AGENDA
PLANNING COMMISSION
116 WEST NEEDLES
BIXBY, OKLAHOMA
July 21, 2014 **6:00 PM**

To: Bixby Planning Commission
From: Erik Enyart, AICP, City Planner *EE*
Date: Friday, July 18, 2014
RE: Report and Recommendations for:
PUD 84 – “Sheridan Cottages” – Haynes Reynolds for 118th & Sheridan, LLC &
BZ-373 – Haynes Reynolds for 118th & Sheridan, LLC

To: Bixby Planning Commission
From: Erik Enyart, AICP, City Planner *EFE*
Date: Thursday, July 10, 2014
RE: Report and Recommendations for:
Preliminary Plat of "Memorial Square Amended" (PUD 6)

MEMORIAL SQUARE AMENDED
PUD 6
Preparation date: JUNE 15, 2014
SHEET 1 OF 3

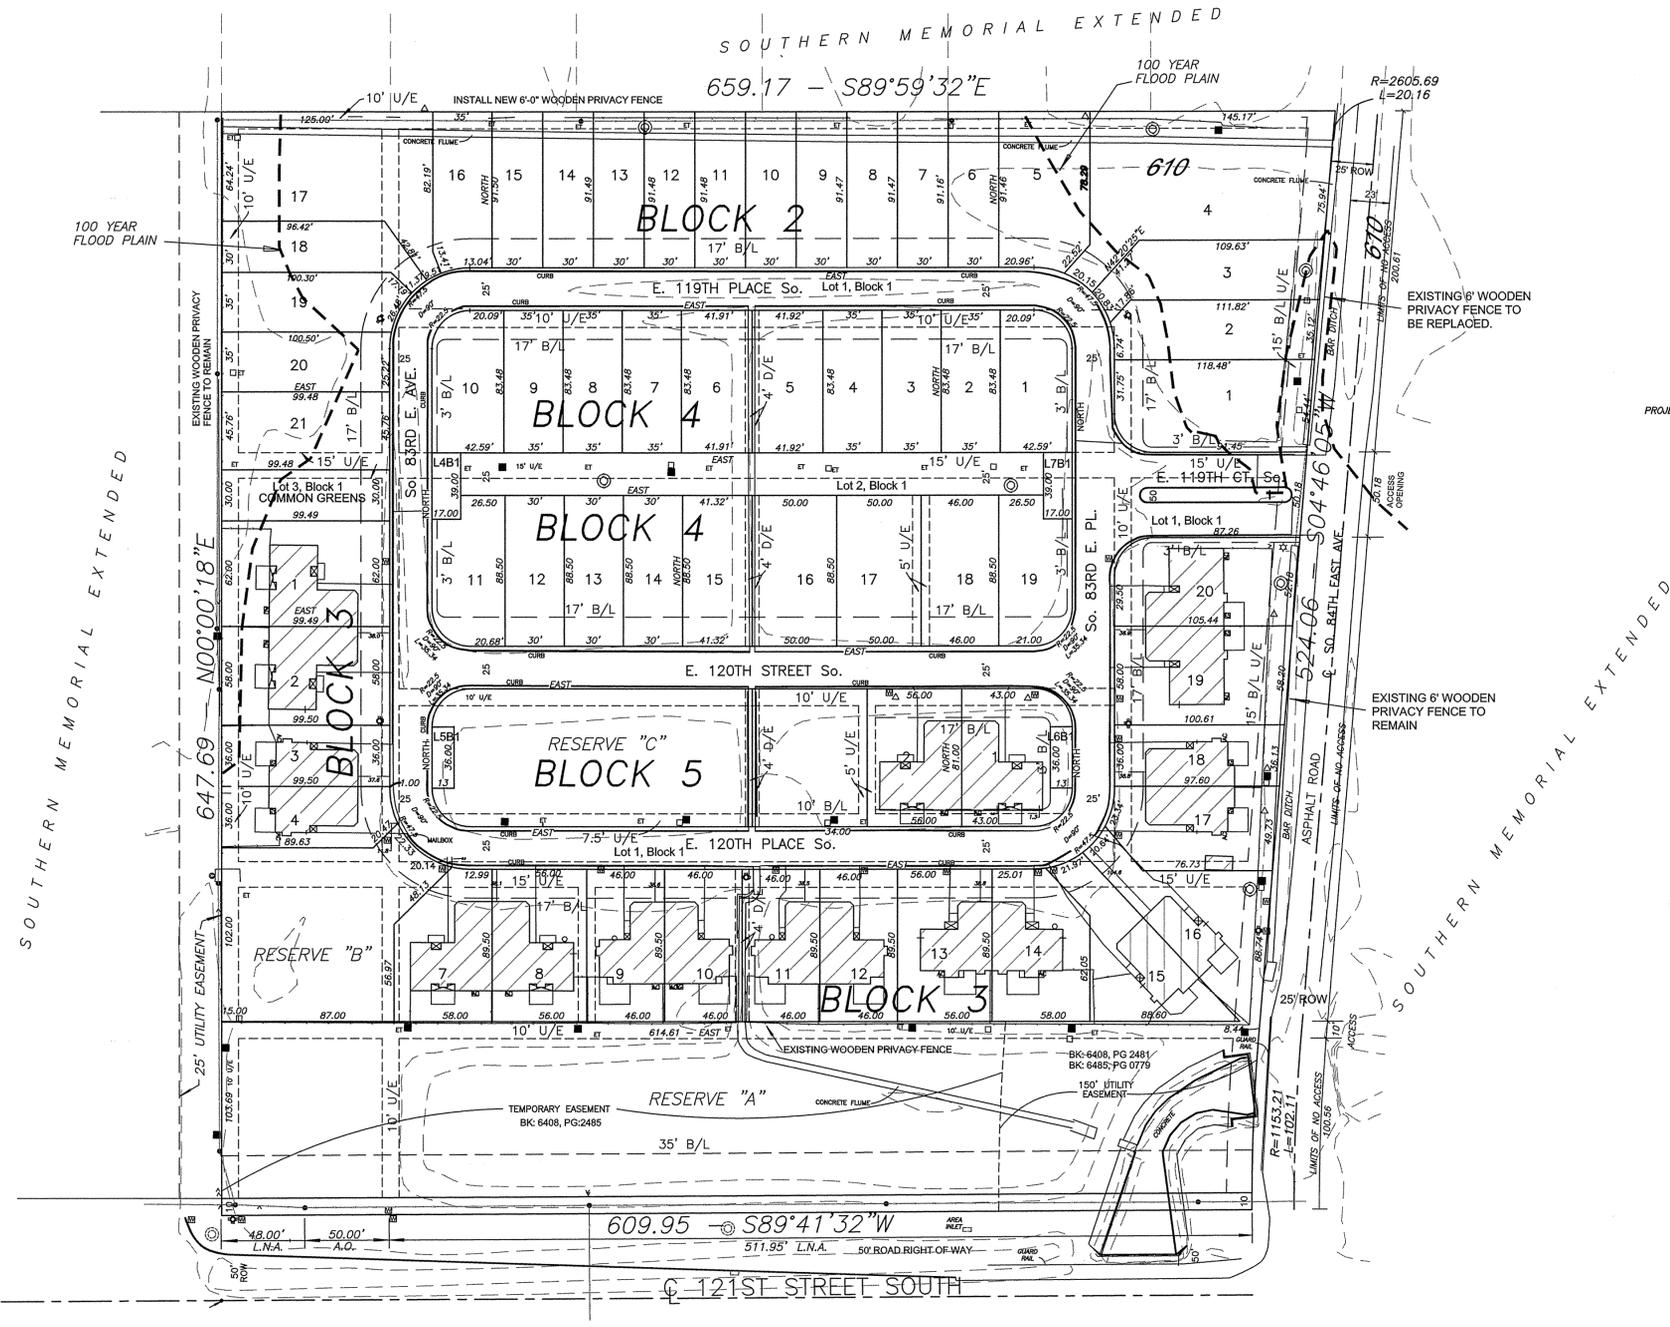
11. Per SRs Section 12-4-2.A.5, please correct Location Map as follows:
 - a. *Southern Memorial Acres Extended* (mislabeled)
 - b. 111th St. S. (mislabeled)

12. Please identify intent of certain numbers which appear in front of certain duplex buildings (e.g. 38.0, 36.5, etc.).
13. Please add lowest permit-able Finished Floor elevation (BFE + 1') per SRs Section 12-4-2.B.5.

15. Please add missing underlying zoning district boundaries as required by SRs Section 12-4-2.B.3.
16. Please correct title of abutting subdivision (missing "Acres") at all three (3) instances.

17. Please add proposed addresses to the lots.
18. Plat missing notes pertaining to monumentation (reference SRs Section 12-1-8).
19. Subdivision Statistics: Please correct the number of lots (67 or 68 lots as per the analysis above).

20. Subdivision statistics: Please add number of Reserve areas.
21. Please add lot areas to allow for review for compliance with minimum lot area standards of PUD 6. A table/schedule may be used if space constraints do not allow within the lot boundaries.

23. "L.N.A." and "A.O." as used on the plat do not match "LNA" or "AO" as used in the Legend – please reconcile.
24. 25'-wide U/E as represented along the rear line of the shopping center to the west – please clarify as being "per Plat # 2600" or cite Book/Page or Document # where recorded.

25. There appears to be a 7.5'-wide U/E along the south side of the duplex lots abutting to the north – please confirm and add, along with "per Plat # 2600" if/as may be the case.

35. Please dimension rear lot line of Lot 3, Block 2.
36. Please clarify meaning of "Temporary Easement."
37. Please add a Drainage Easement or widen the U/E such that it fully contains the concrete flume shown in Block 2.

38. LNA distance missing from frontage of Block 3.
39. Please represent existing buildings and dimension to nearest property lines as required by SRs Section 12-4-2.A.8. As noted during the PUD Major Amendment # 1 review, if any existing buildings do not meet proposed setbacks, the setbacks may be amended at this time to resolve such issue(s). Setbacks and other such details may be removed on Final Plat by standard Modification/Waiver written into Staff Report as a Condition of Approval.

44. Please correct southerly 84th E. Ave. R/W label to 50' (total width), label 50' R/W as to Centerline of 121st St. S., and label additional 10' R/W for 121st St. S. R/W as per the plat of *Memorial Square*.

45. Street frontages of existing Lots 5 and 6, Block 3 should be consolidated or a common lot corner point should be added and dimensions indicated to respective frontages.

57. Property lines appear to be missing from southeast corners of Lots 15 and 16, Block 3.
58. Please clarify several unidentified linetypes along and somewhat paralleling the easterly sides of lots fronting on 84th E. Ave., one of which is identified as an "Existing 6' Wooden Privacy Fence to Remain."

59. Common lot line between Lots 3 and 4, Block 3 appears to have a 1' variance to the point of tangent/curvature. Please clarify, such as by detail diagram, on which side of the common lot corner the 1' variance is located, due to its exceptionally small size and the scale of the plat. Alternatively, the common lot corner may be made coterminous with the point of tangent/curvature by moving the angle/bearing of the easternmost portion of the common lot line (such as that part easterly of the 17' B/L).

BRISBANE OFFICE PARK
PUD 60
Preparation date: June 15, 2014
SHEET 1 OF 3

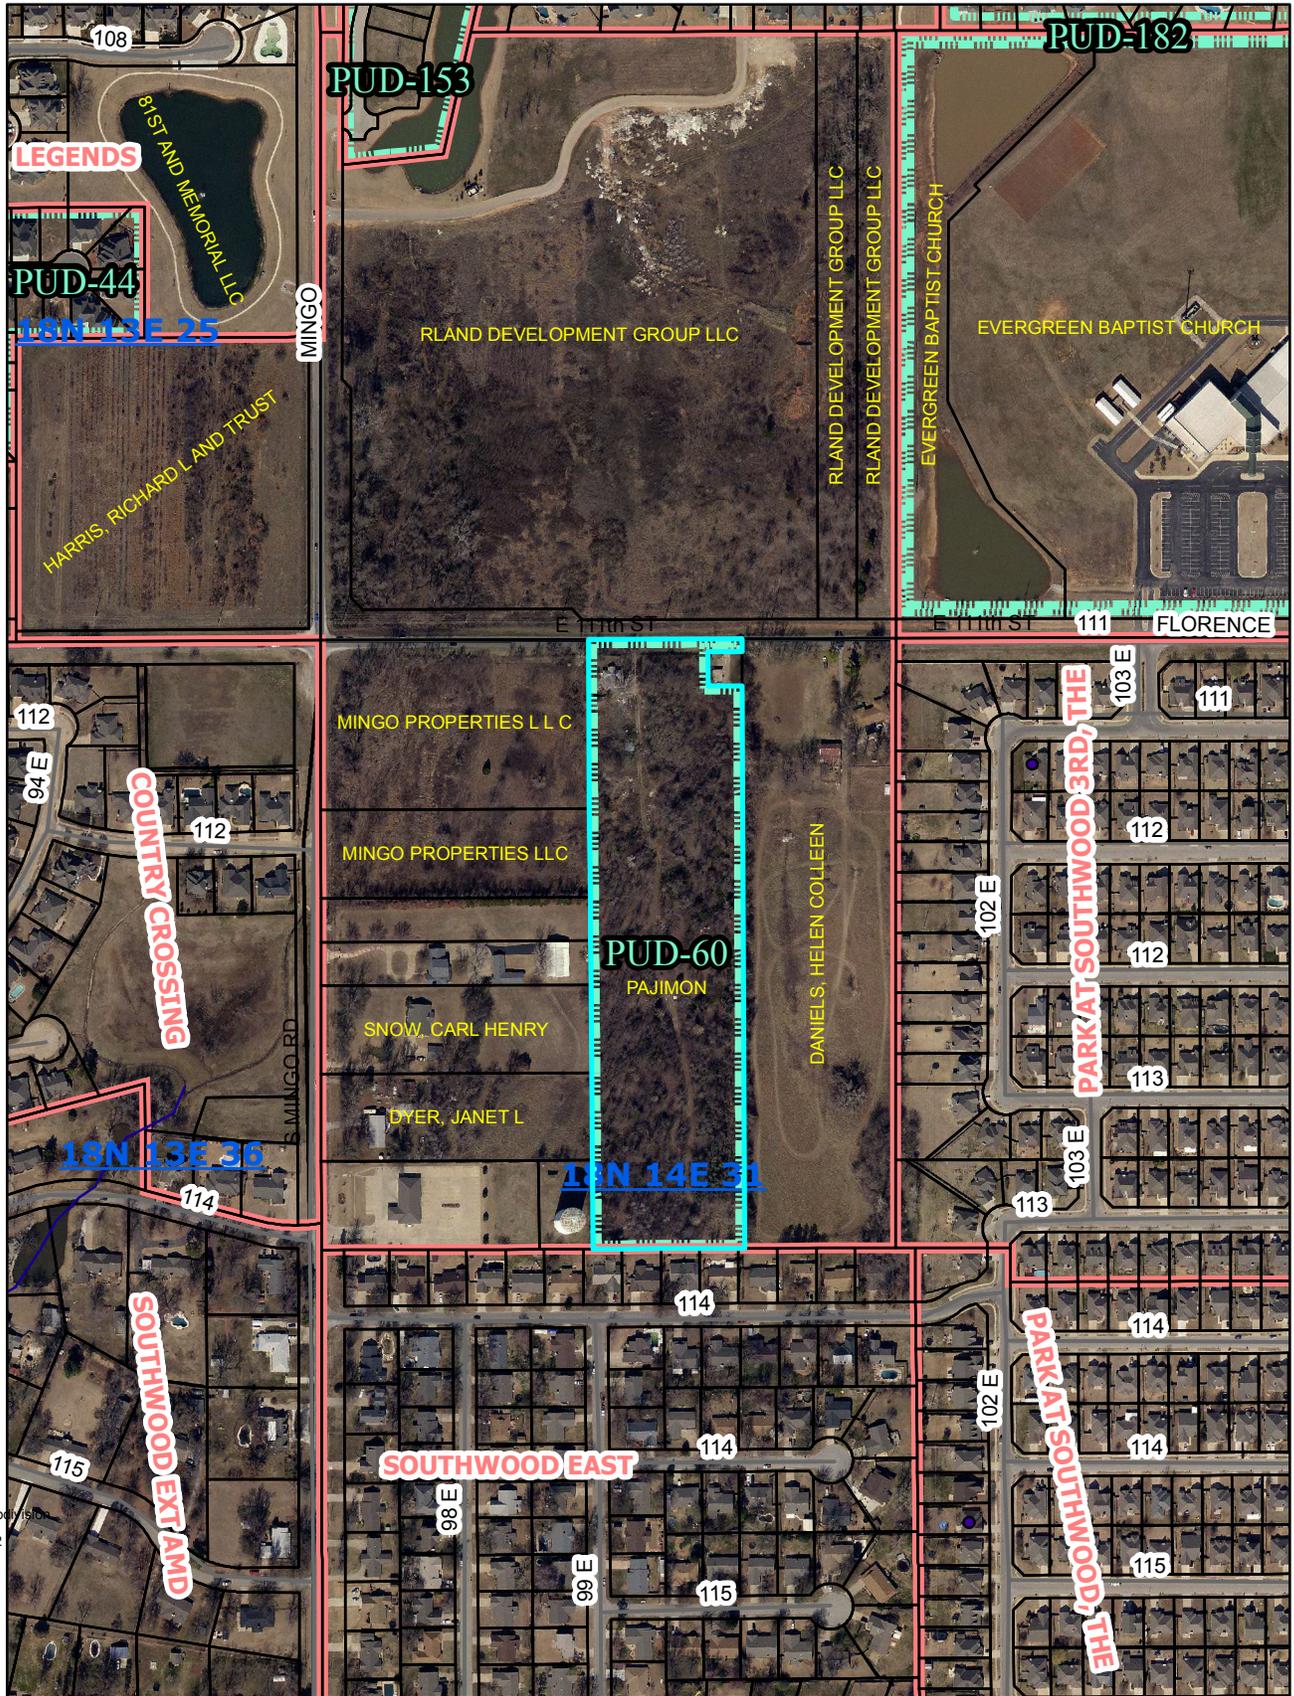
Limits of No Access (LNA) are currently proposed along 111th St. S. except for access point(s), which must be approved by the City Engineer and Fire Marshal.

1. Subject to the final approval of PUD 60 Major Amendment # 1 by ordinance.
2. Subject to compliance with all Fire Marshal, City Attorney, and City Engineer recommendations and requirements.

3. Limits of No Access (LNA) and Access Openings subject to City Engineer and Fire Marshal approval.
4. Subject to a Modification/Waiver from Subdivision Regulations Section 12-3-4.B to allow Lot 2, Block 1, to have no frontage on a private or public street. This may be justified by citing the configuration of the subject property and the Approved PUD 60 and Conditionally Approved PUD 60 Major Amendment # 1 which specifically designed the development in this manner and provided that the frontage requirement was set aside.
